Modification of Blade Shaft Seals

The area marked red has to be removed

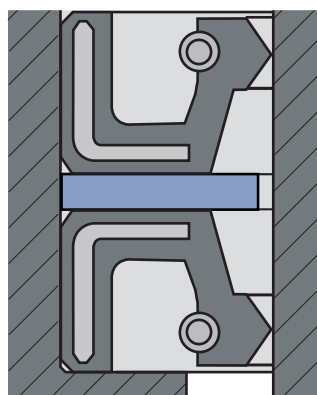
Depending on the age of your propeller you might need to modify the balking rings between the shaft seal rings of your blade shaft seals. Modern shaft seal rings have an internal reinforcement and must not be used with the old balking rings. The shorter design of modern shaft seal rings requires a modification of the balking rings. Otherwise, serious leakage would occur.

If the design of the existing balking rings is similar to the sketch on the right, the area marked red must be removed. After the modification the rings will act as spacer rings.
